# MICROCHIP PIC18F8720/8620/6720/6620

## PIC18F8720/8620/6720/6620 Rev. A4 Silicon/Data Sheet Errata

The PIC18F8720/8620/6720/6620 parts you have received conform functionally to the Device Data Sheet (DS39609B), except for the anomalies described below.

**FIGURE 26-3: PIC18F6620/6720/8620/8720 VOLTAGE-FREQUENCY GRAPH (INDUSTRIAL, EXTENDED)**

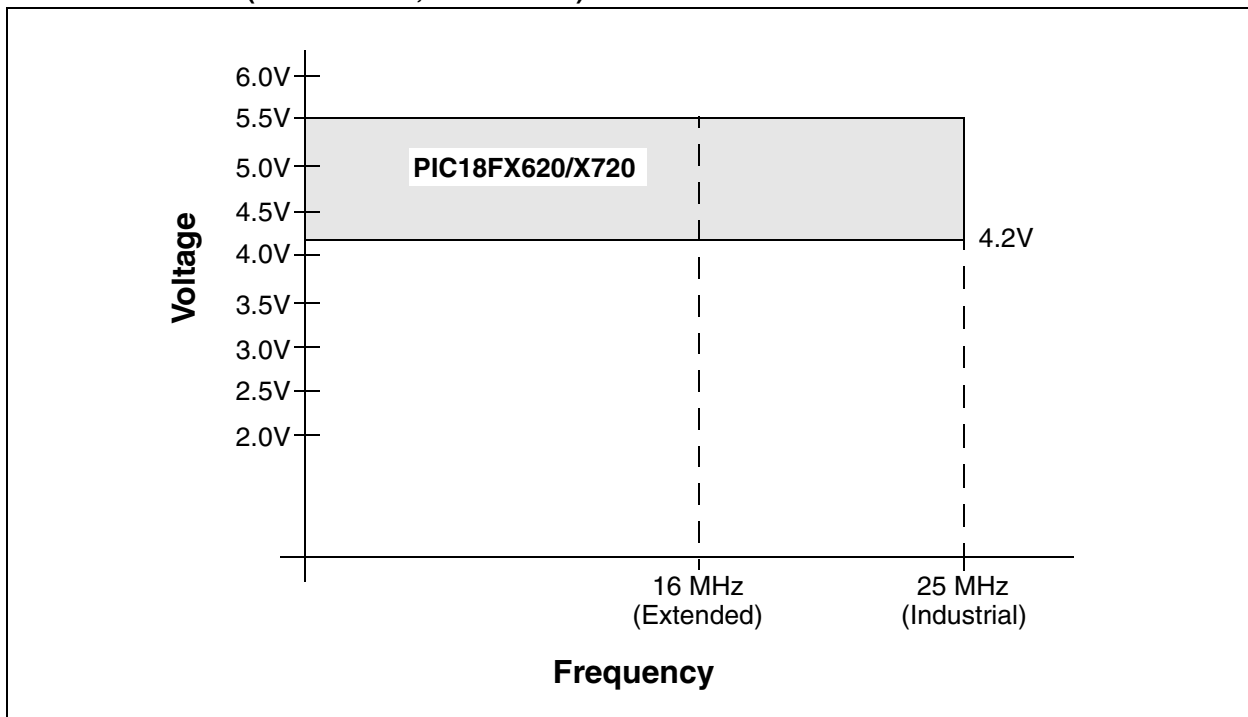
In Section 26.0 “Electrical Characteristics”, the following figure has been updated to clarify the voltage frequency for Extended devices.

**FIGURE 11-1: TIMER0 BLOCK DIAGRAM IN 8-BIT MODE**

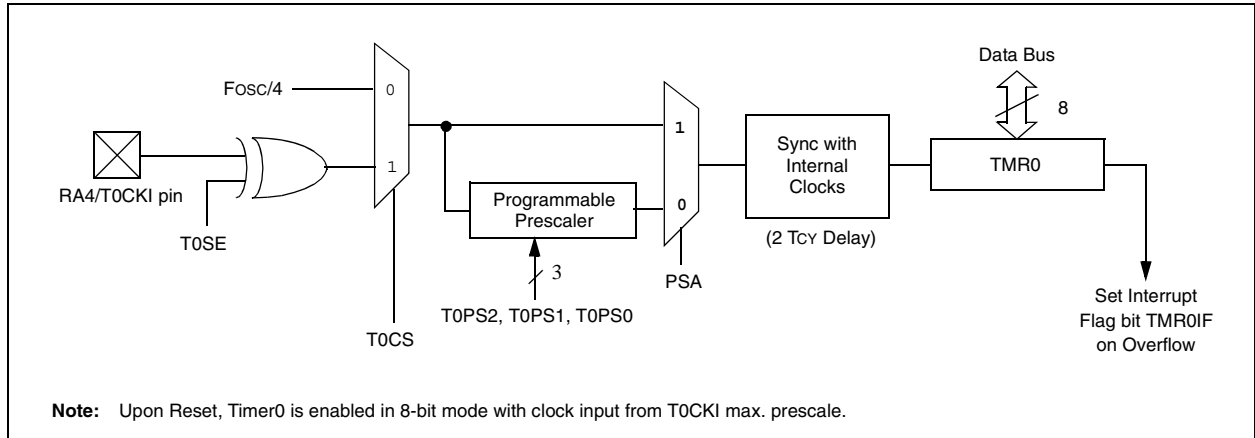
The PSA multiplexor bit values in Figures 11-1 and 11-2 do not match the text description of the Timer0 PSA bit in the T0CON register.

The bit values have been corrected by swapping the values as shown below (correct values are shown in **bold text**):
